ADDENDUM NO. 1

TO: All Holders of Plans and Contract Documents for City of Monett,
OOOS(628) Chapell Dr over BNSF Railroad,
Bridge # 2870013

ISSUED: 07/02/2026

SECTION A-A

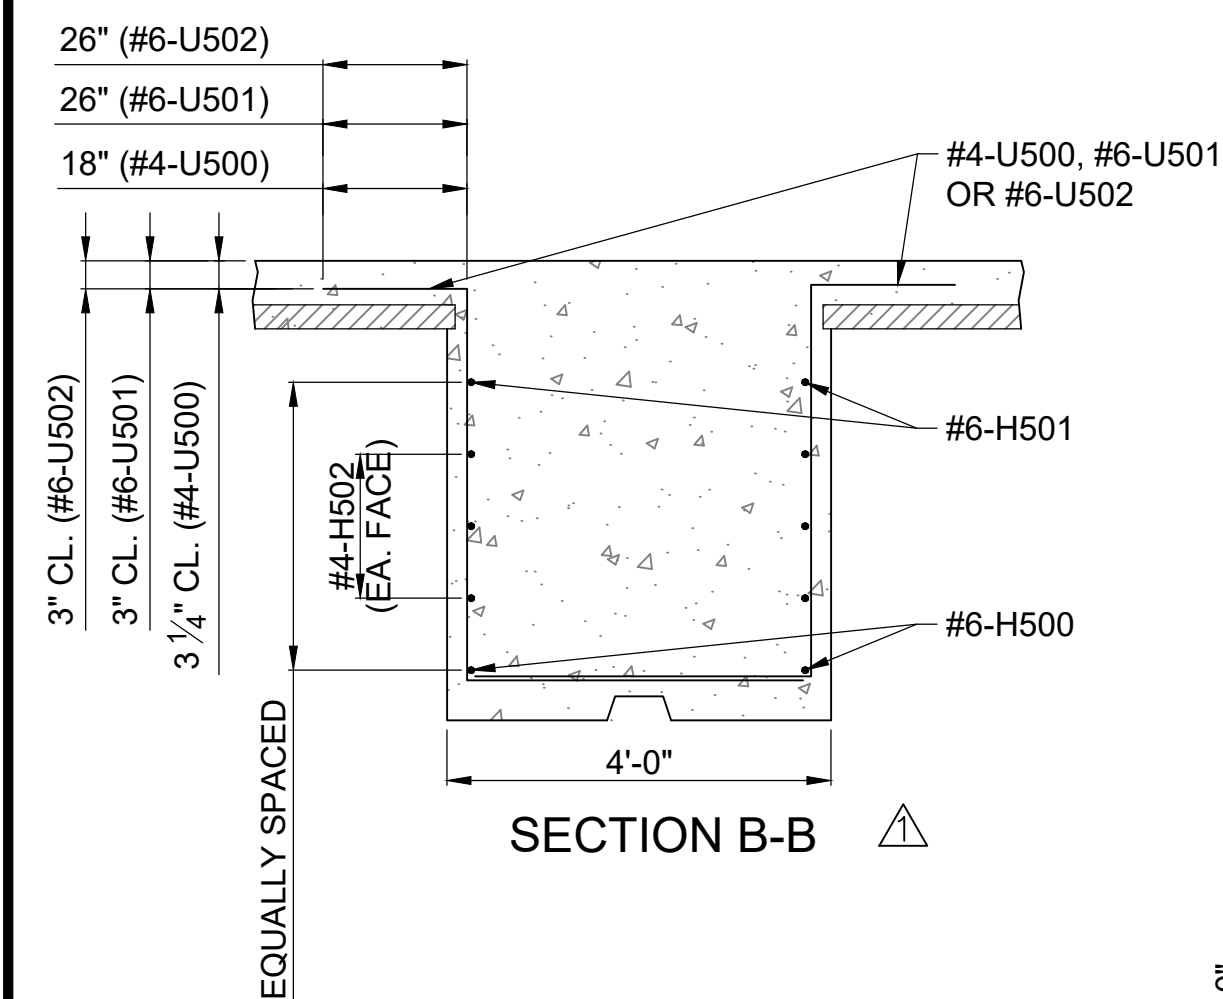
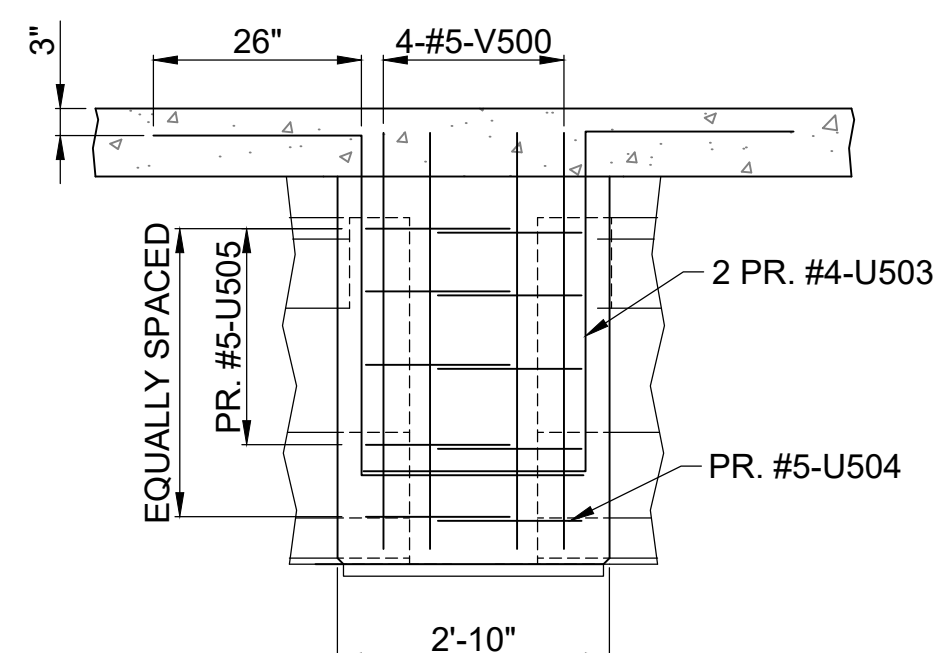
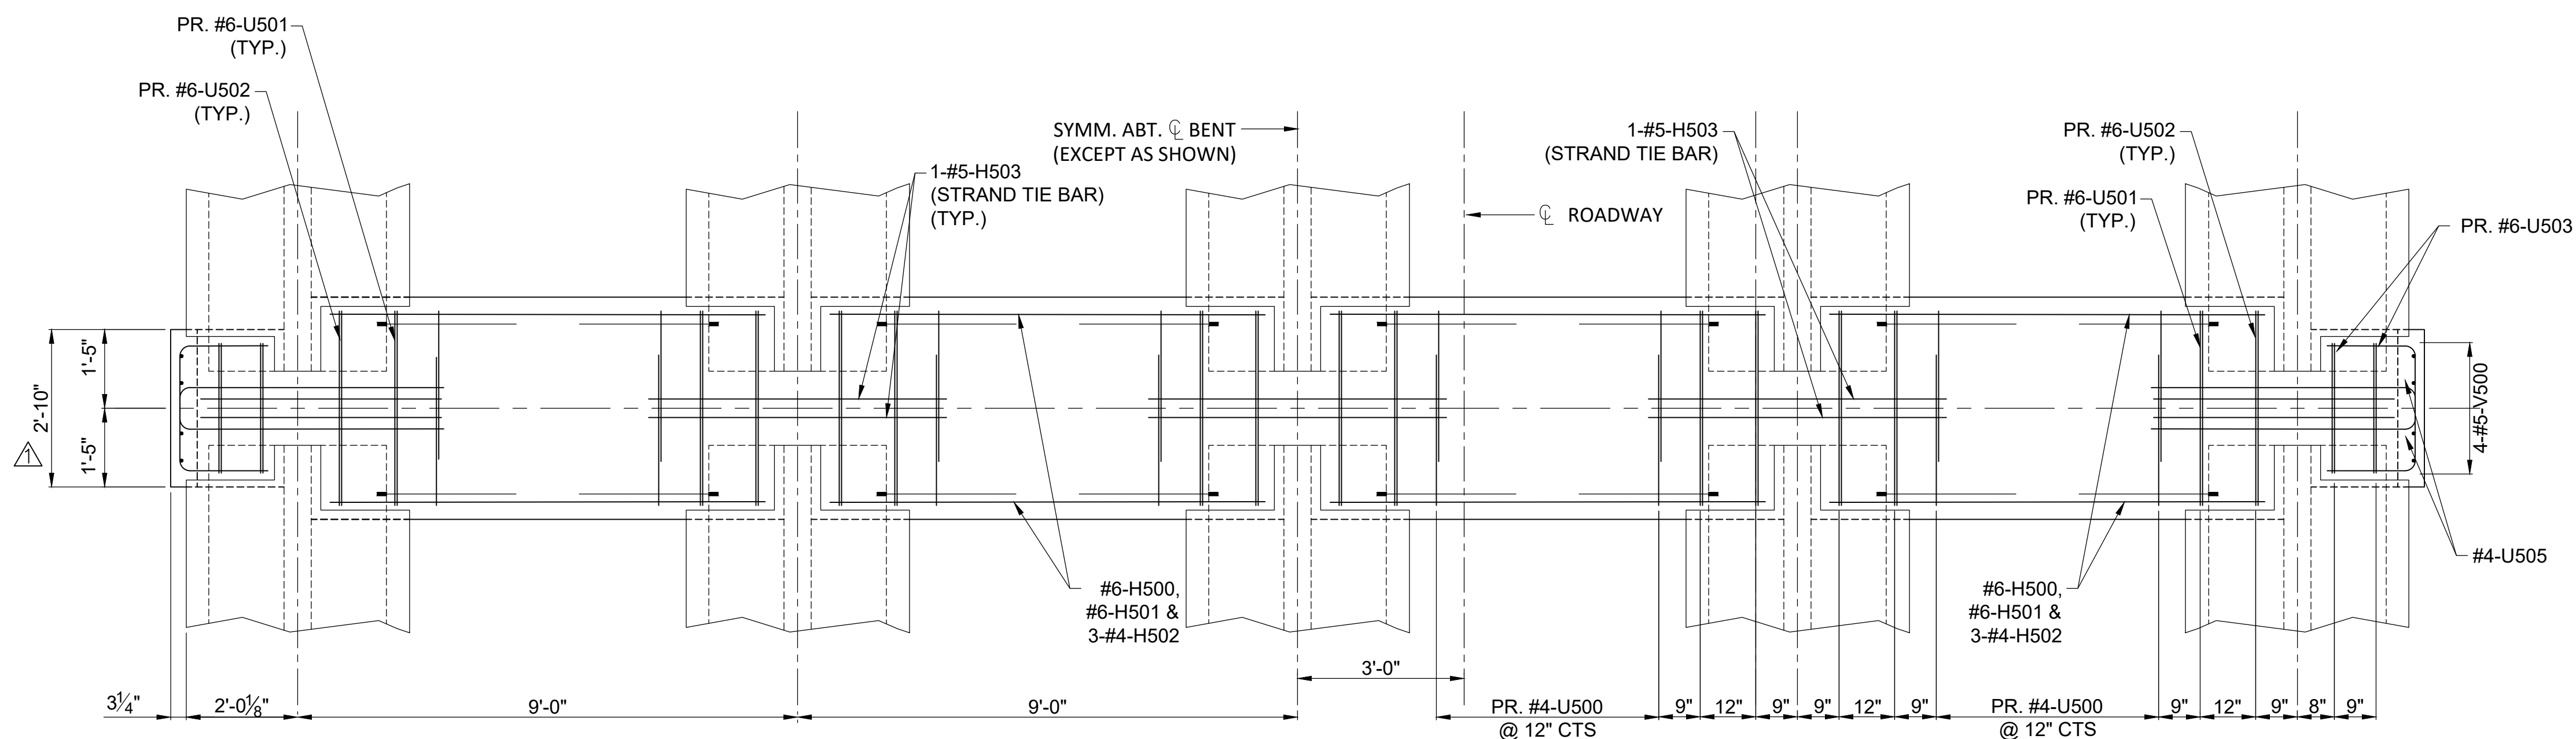
- Revised “Int. Bent” dimension from 18½” to 14½”
- Sheet 45 – Concrete Diaphragms at Bents
 - Revision to Section A-A
 - Revision to plan view to be drawn to scale

- Revision to edge dimensions
 - Diaphragm edge out-out dimension from 3’-5” to 2’-10”
 - Diaphragm edge centerline-out dimension from 1’-8 ½” to 1’- 5”

- Revision to Section B-B
 - Diaphragm width dimension added
 - Revision to Section C-C
 - Diaphragm edge dimension added
- Sheet 60 – Bill of Reinforcing
